TSB150177
-----------

## Technical Service Bulletin

New Two Wire Coolant Level Sensor Introduction

Figure 1, OEM Engineered Plastic Components (EPC) Connector

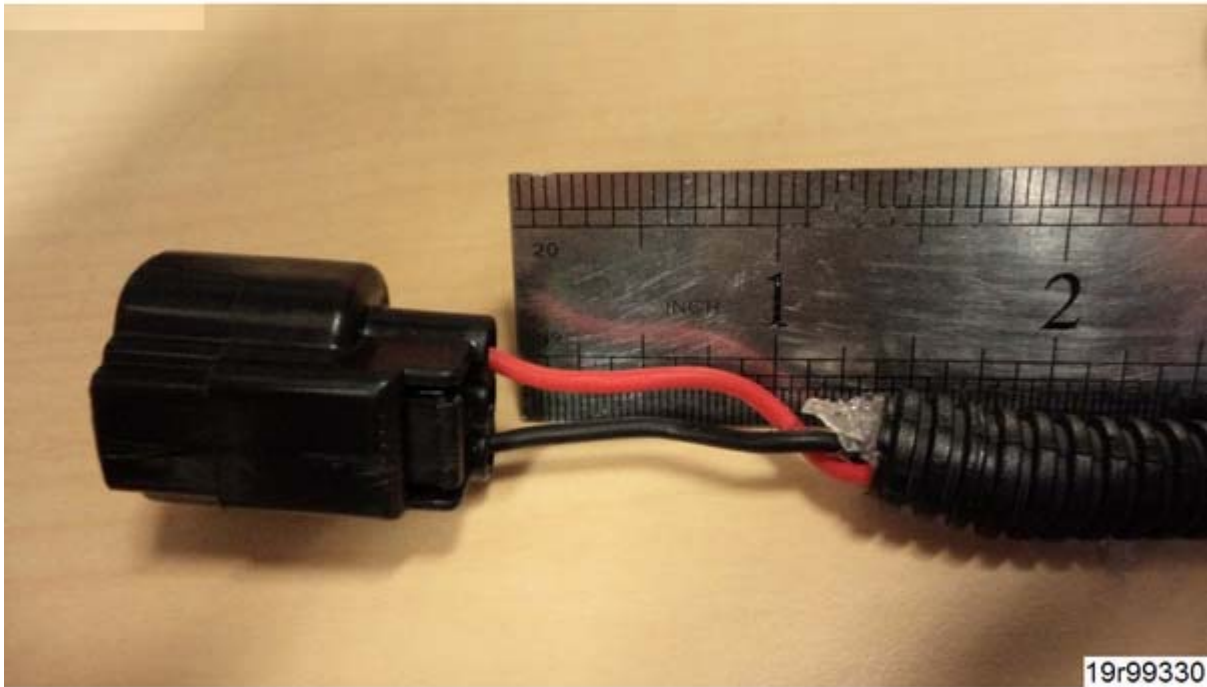
ISB6.7 CM2350 B101 and ISL9 CM2350 L101 equipped transit bus applications with coolant level sensor, Part Number 2872933, are experiencing pin corrosion as the result of poor sealing performance of the original equipment manufacturer (OEM) Engineered Plastic Components (EPC) connector.

- See the ISL9 CM2350 L101 Service Manual, Bulletin 4310787. [Refer to Procedure 019-017](#) in Section 19.
- Cut the OEM harness 25.4 mm [ 1 in ] behind the OEM Engineered Plastic Components (EPC) connector. See Figure 1 below.

- Install electrical connector, Part Number 5299971. See Figure 2 below.
  - See ISB6.7 CM2350 B101 Service Manual, Bulletin 2883567. [Refer to Procedure 019-199](#) in Section 19. Reference Solder Splice section.

Figure 3, New Coolant Level Sensor for ISB6.7 CM2350 B101 and ISL9 CM2350 L101  
Transit Applications, Part Number 4359193

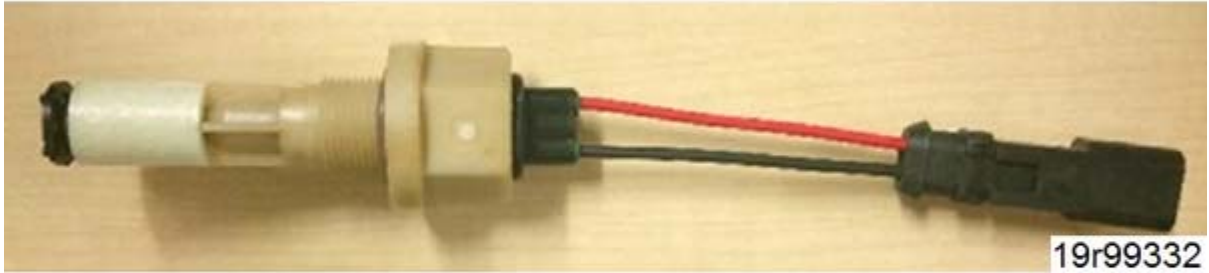
- See the ISL9 CM2350 L101 Service Manual, Bulletin 4310787. [Refer to Procedure 019-199](#) in Section 19. Reference Solder Splice section.
- Install new coolant level sensor, Part Number 4359193, into the surge tank and connect to electrical connector, Part Number 5299971. See Figure 3 below.

- New coolant level sensor, Part Number 4359193, is **not** compatible with the OEM Engineered Plastic Components connector. The OEM Engineered Plastic Components connector will need to be cut off and replaced with electrical connector, Part Number 5299971, for the first time repair.
